# HOW TO SELECT APCO SLOW CLOSING AIR/VACUUM VALVES

SLOW CLOSING AIR/VACUUM VALVES

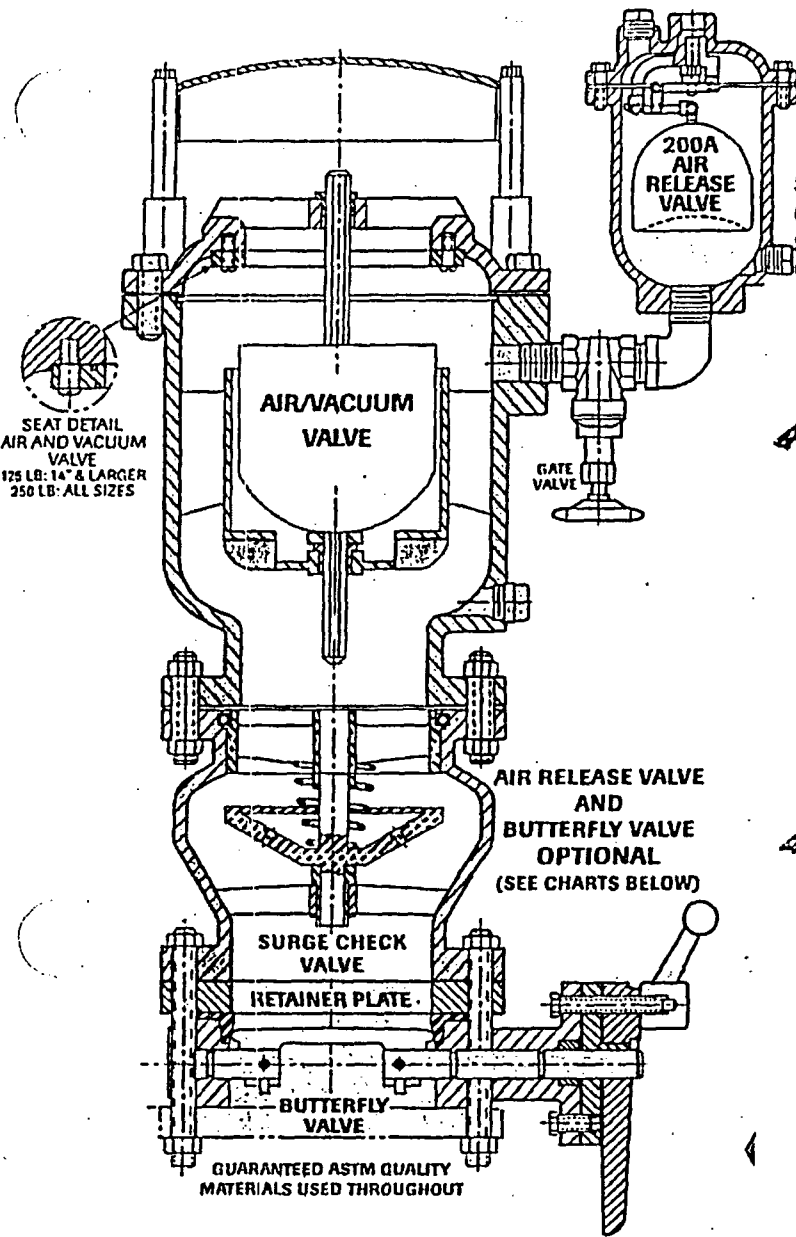
← THIS THE "float" VALVE THAT SEALS the vacuum breaker. THIS float failed causing the 2000 GVENT.

← THIS SURGE VALVE DID NOT EXIST PRIOR TO 2000. IT WAS ADDED AS A CORRECTIVE MEASURE AFTER THE 2000 EVENT TO PROTECT THE float VALVE.
